ADDENDUM

Project Name: Elevator Modernization at: Lampe Hi-Rise (IL 16-4)

Addendum Number: 2

Issued: 05/08/2019

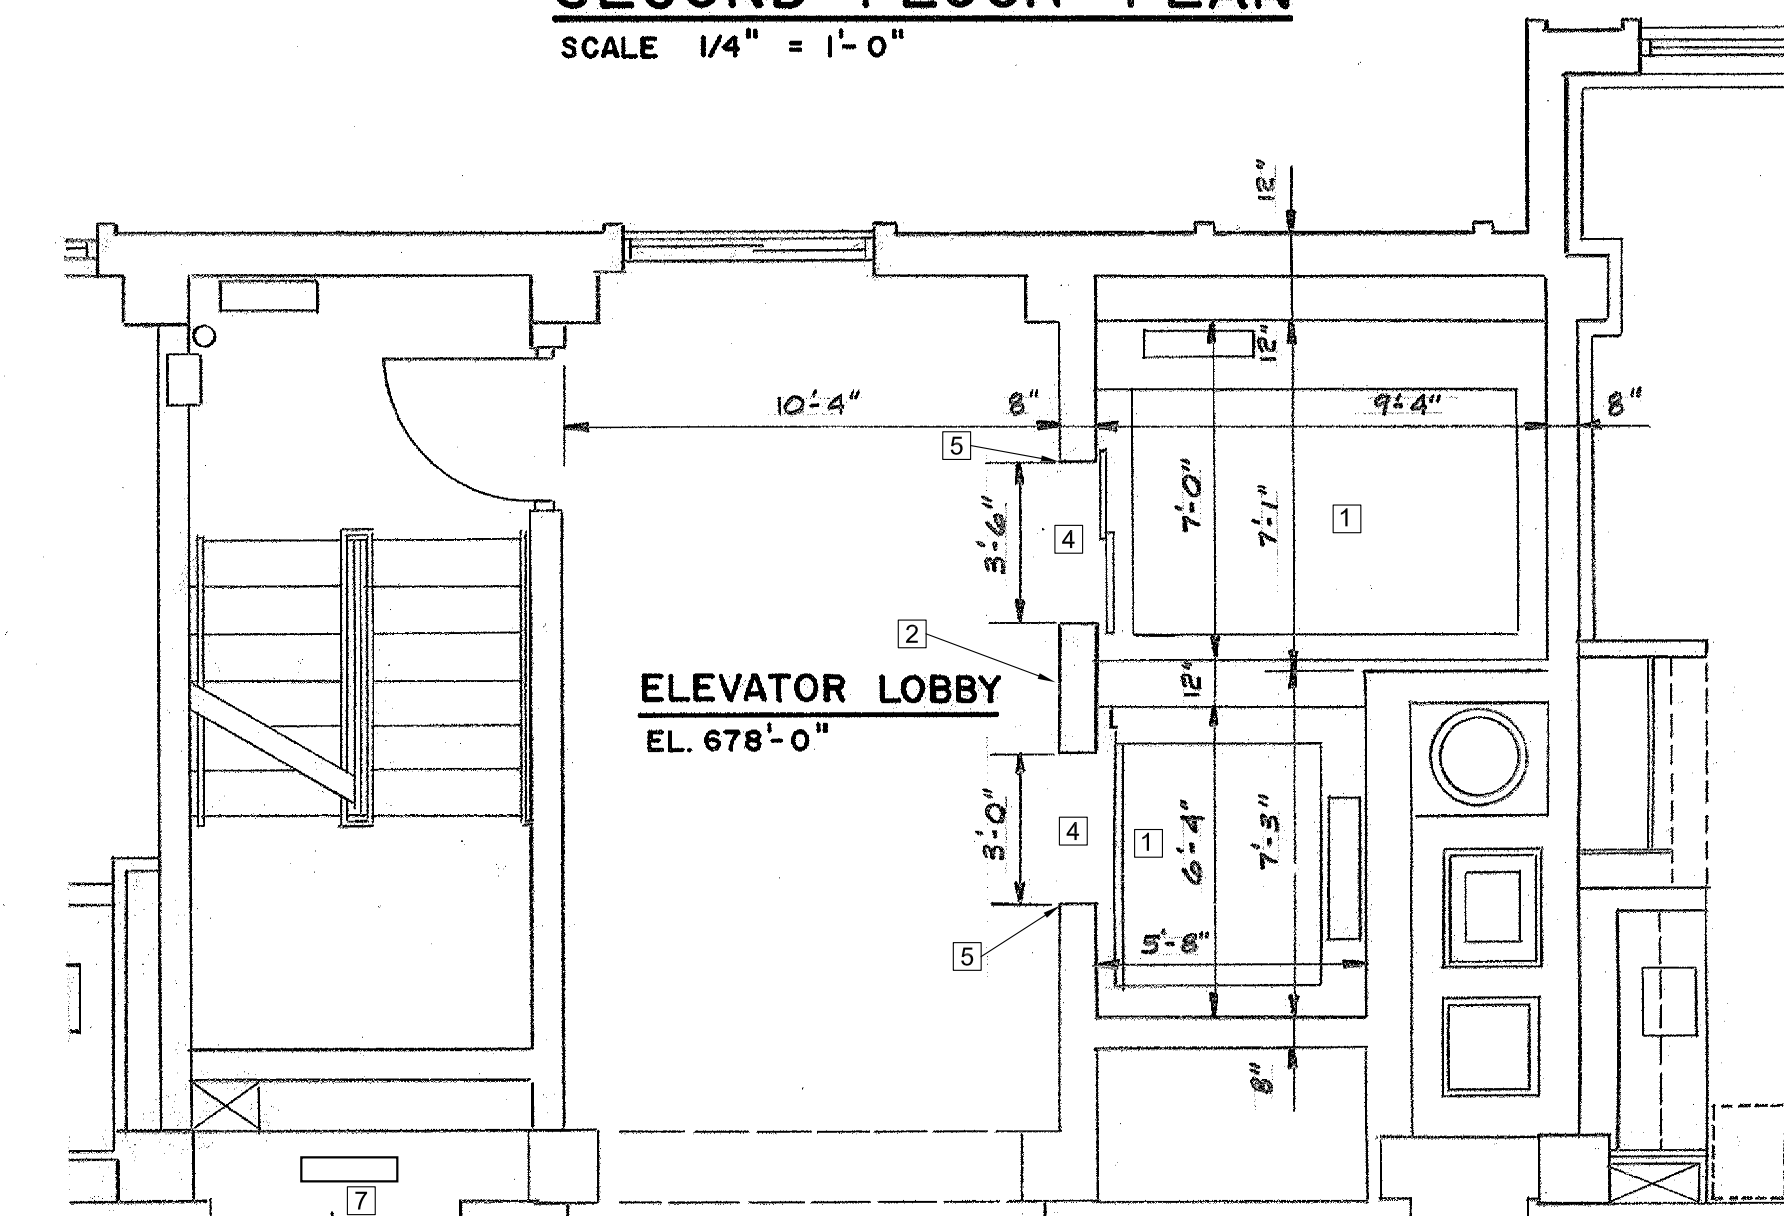
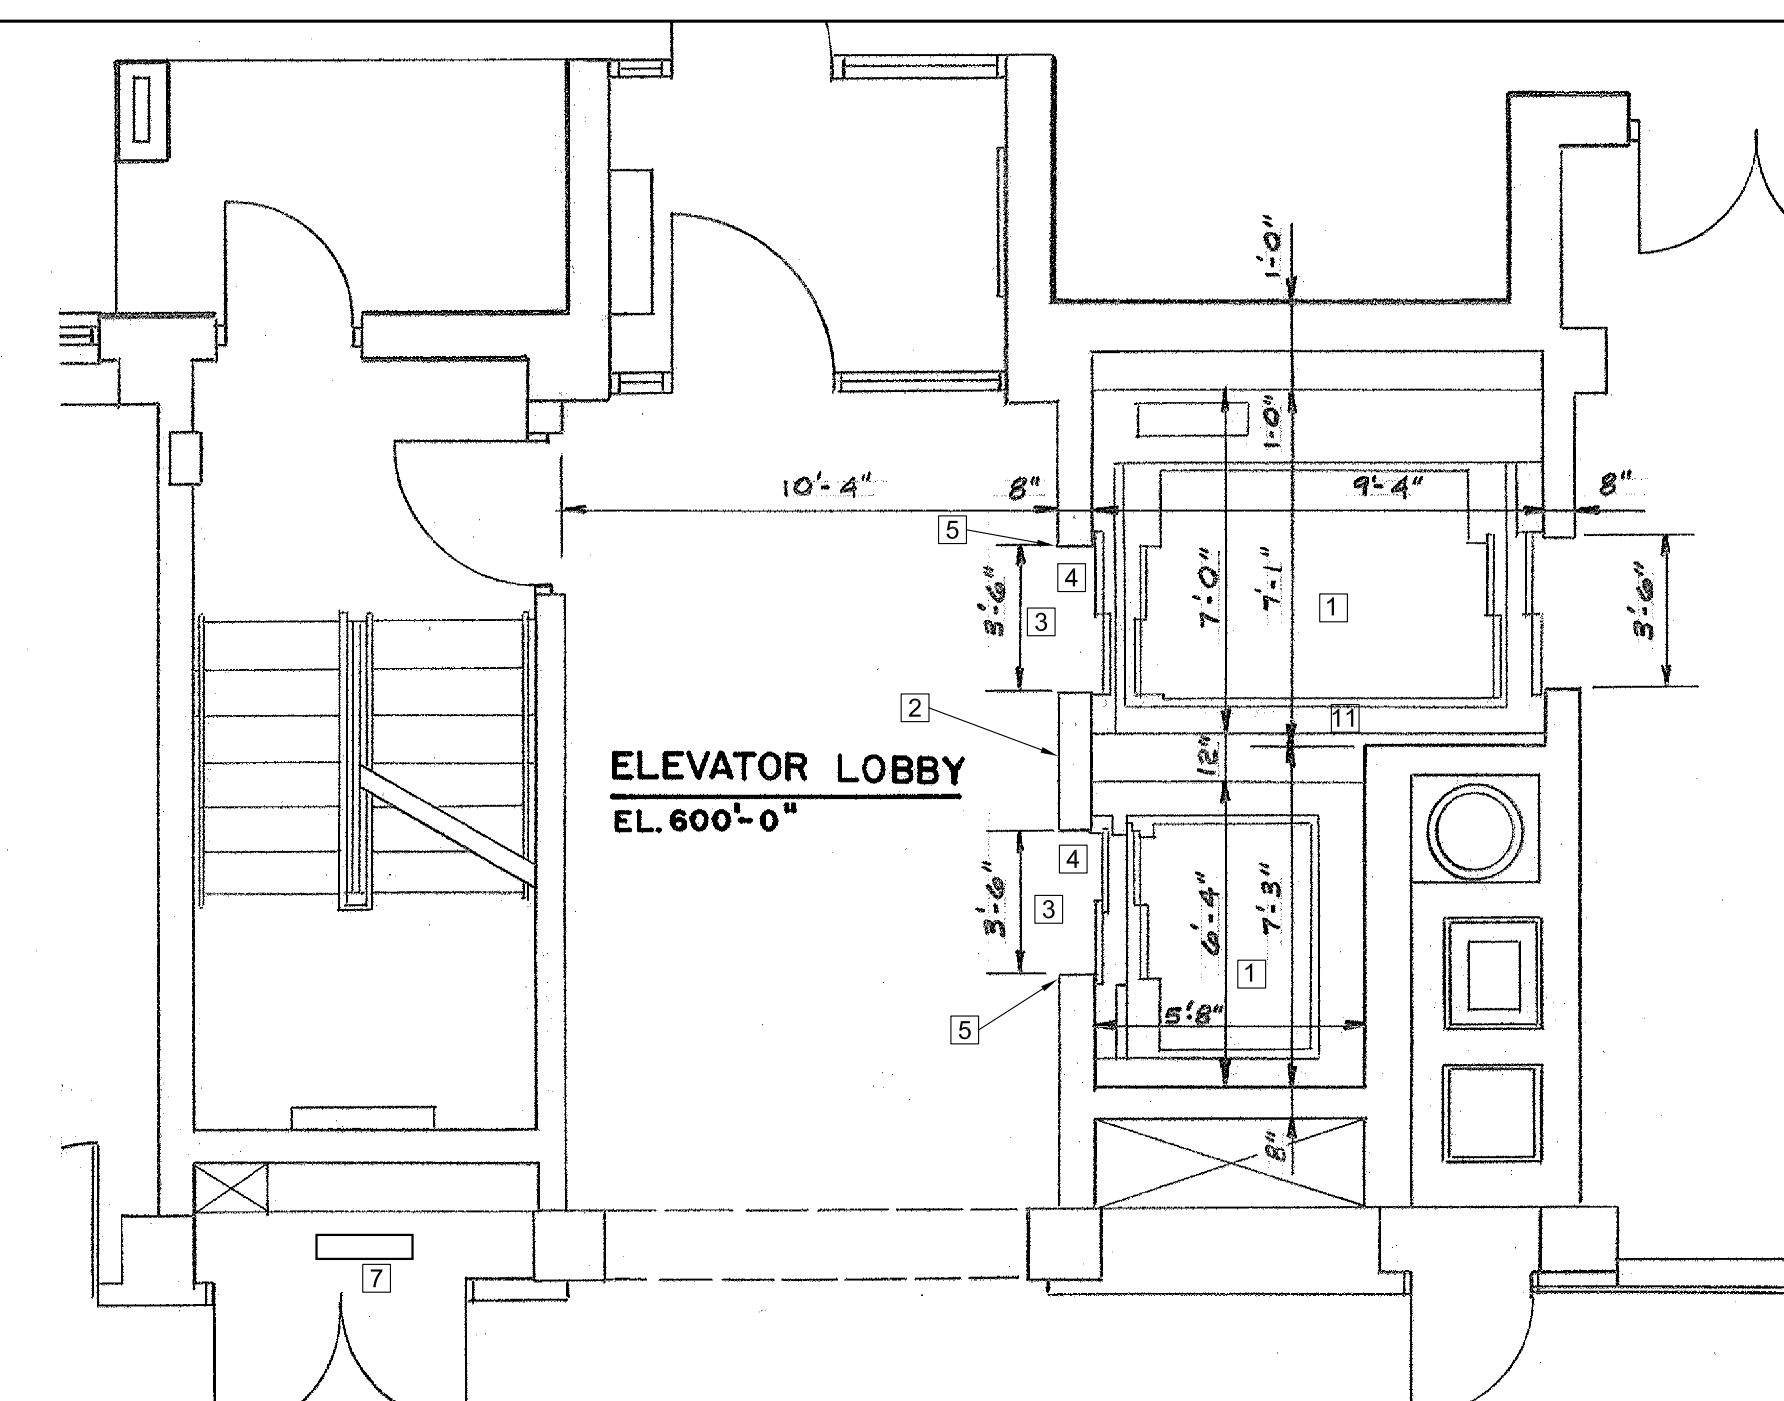
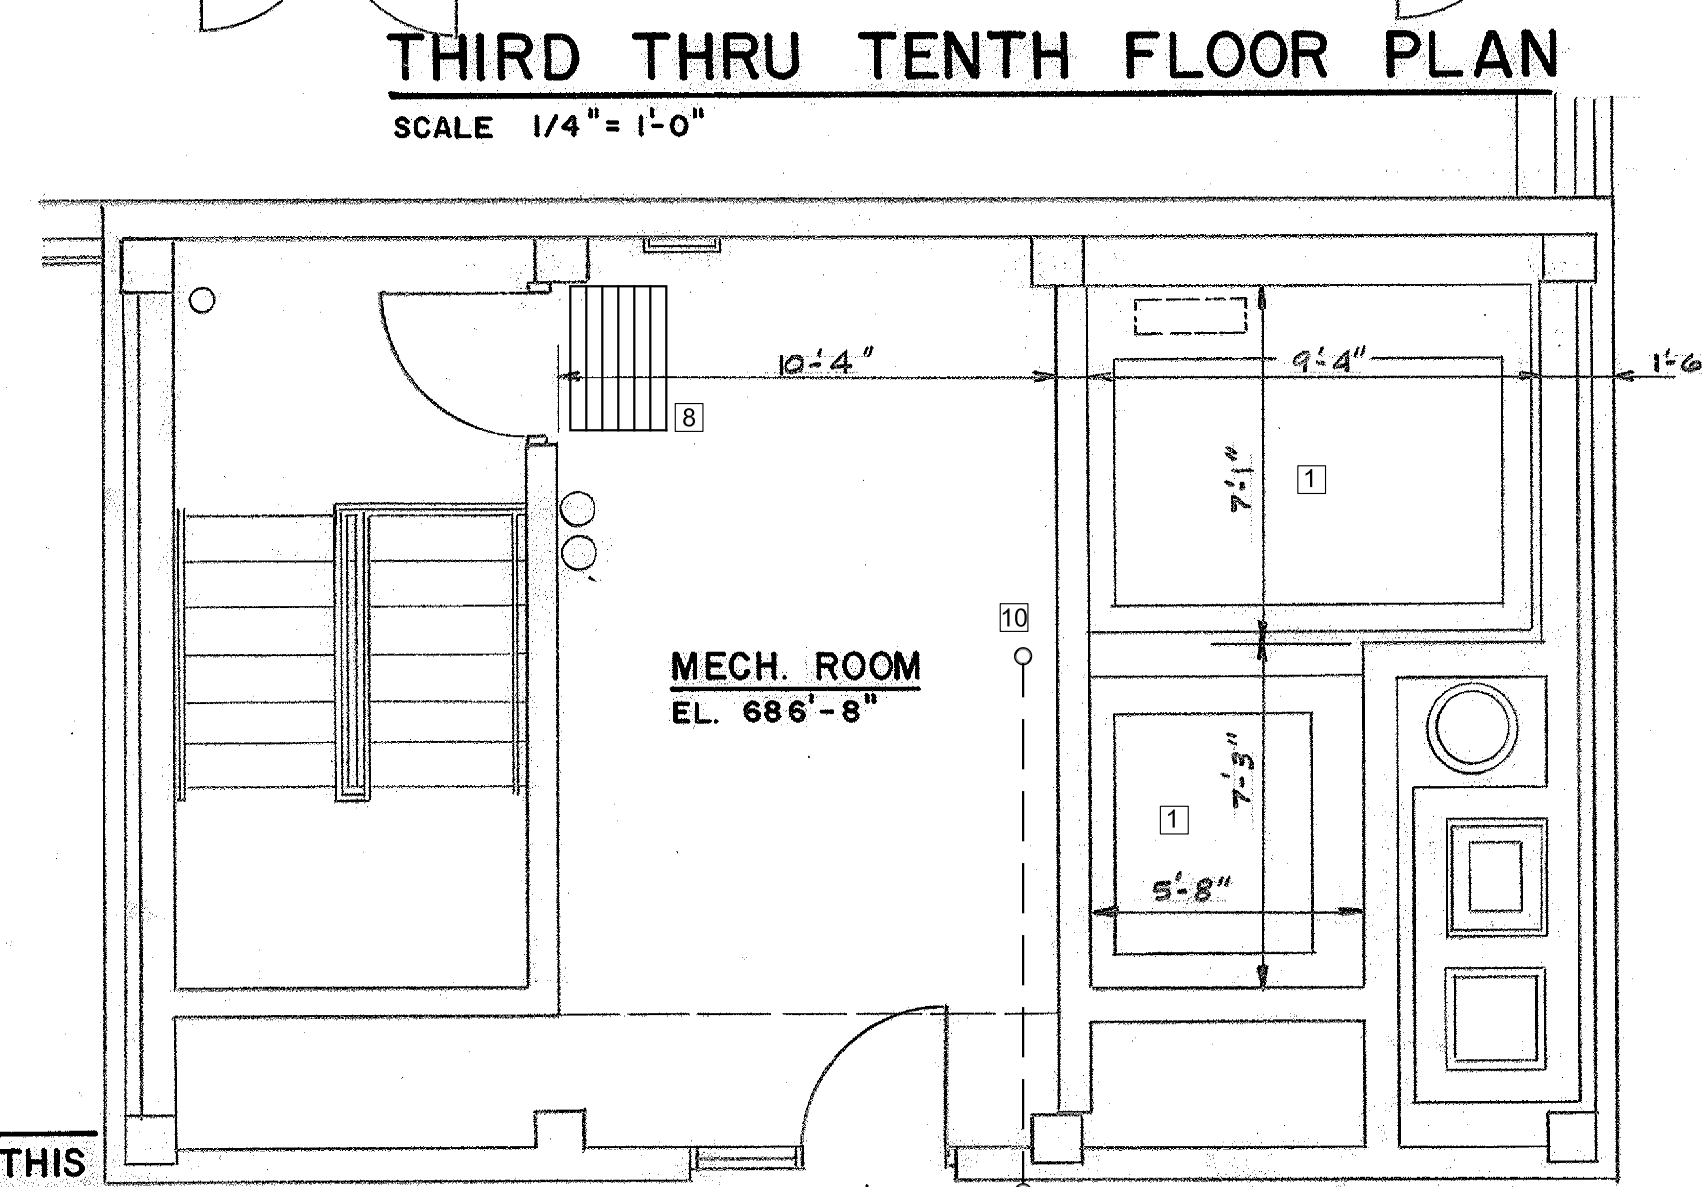
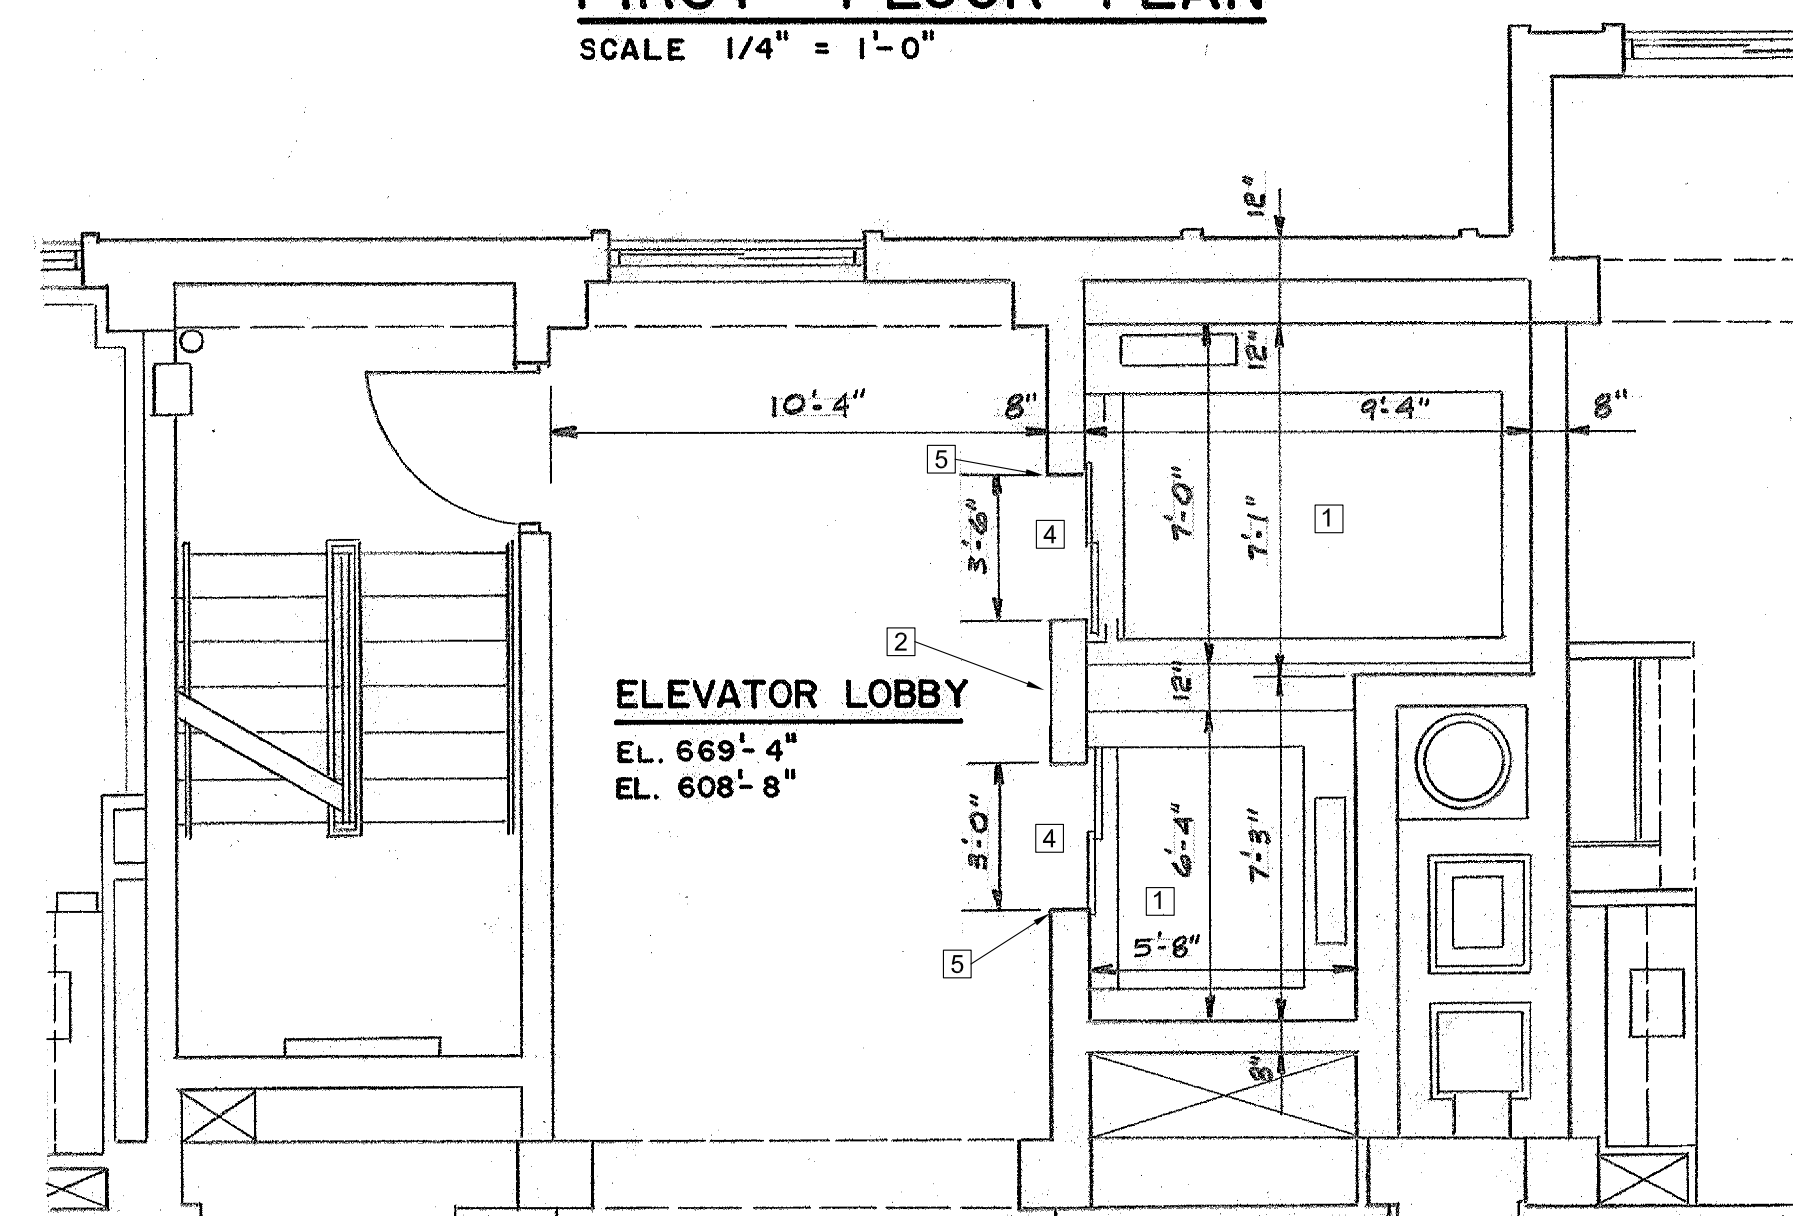
ITEM	DESCRIPTION	NOTES
SPECIFICATIONS:		
Form of Bid	Revise	Any products not otherwise listed shall be considered as an acceptable substitute under Alternate Bid "A-2". Contractor shall include a list of all proposed substitutions as well as the overall addition or deduction to the Base Bid price on the revised Form of Bid.
Section 14210 (2.02) (A)		
Section 14210 (2.02) (B)		
Section 14210 (2.03) (A)		
Section 14210 (2.04) (D)	Clarify	Communications systems and data line work shall be by the Base Bid "A" contractor.
Section 14210 (2.06) (A)	Clarify	Exterior side of door to be hand-painted in the field.
DRAWINGS:		
A101	Clarify	Electrical lighting fixtures and switches in elevator pit to remain.
A101	Clarify	Base Bid "B" contractor to provide new sump pump in existing pit. See revised Dwg. A101.
